**SEWAGE DISPOSAL SYSTEM**  
HOWARD COUNTY HEALTH DEPARTMENT  
BUREAU OF ENVIRONMENTAL HEALTH  
410-313-2640

P. 513299-B

A. REPAIR

REPAIR - PURPOSE- EXISTING SEPTIC SYSTEM HAS FAILED.

513299-B

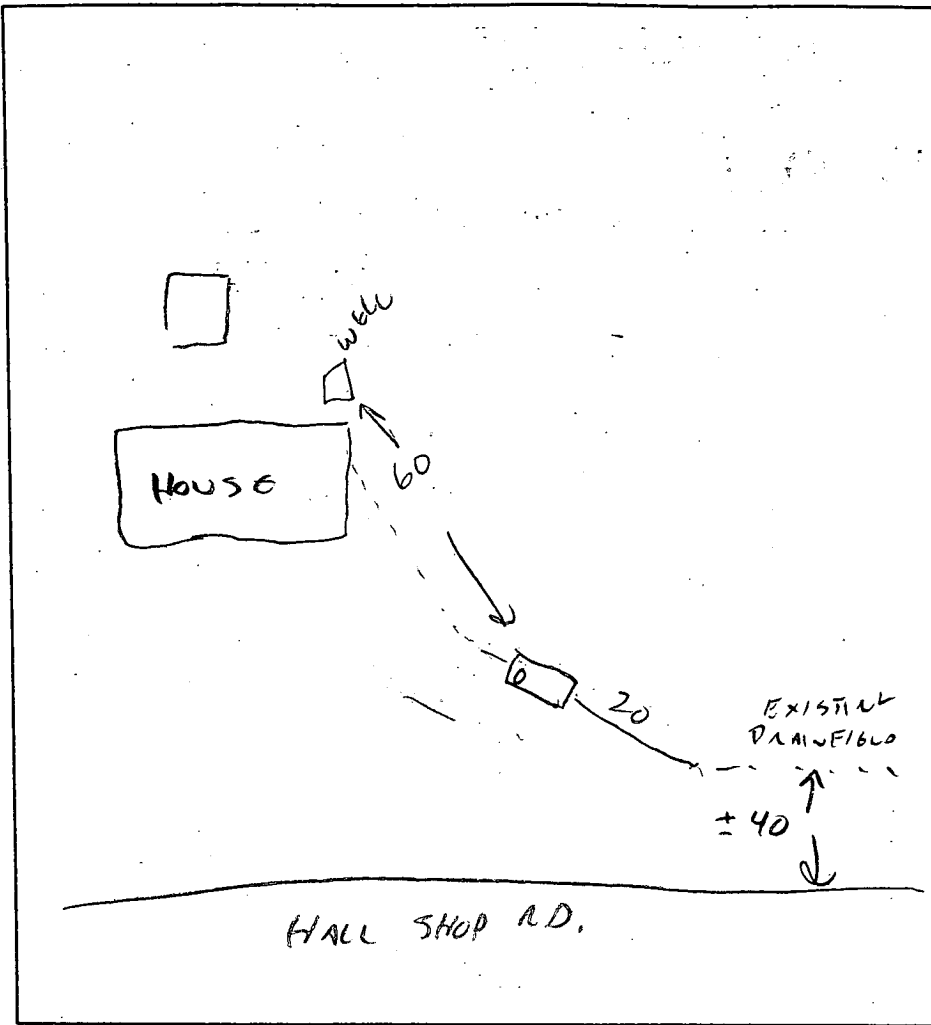
PRE-CONSTRUCTION INSPECTION: STEEL 500 GAL TANK COLLAPSED.

INSPECTION COMMENTS: 1000 GAL TANK RE-SET AT ORIGINAL LOCATION,  
60' FROM WELL - NOT PRACTICAL TO SET AT DIFFERENT LOCATION  
& STILL MAINTAIN FLOW TO EXISTING DRAINFIELD. 3/10/00 CW
